R03HB

Seat Frame Anchorage

MODELS AFFECTED: All School Buses Equipped With Seat Belts or Seat Belt Ready Seats

RECALL CAMPAIGN RO3HB

ISSUE

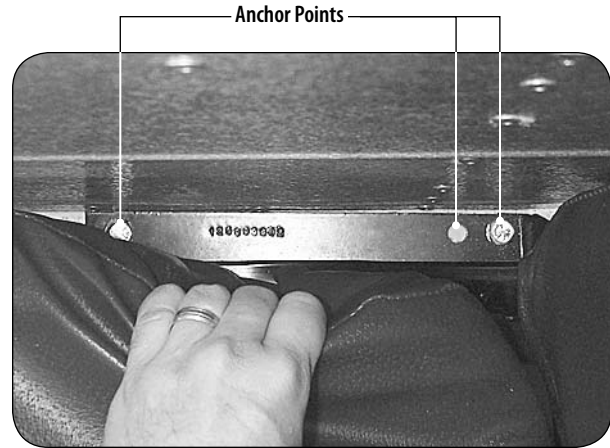
Seat frame to ledge anchoring may be missing anchor bolts.

Inspection of each seat frame to ledge anchoring point and installation of additional bolts as necessary. Three bolts are required.
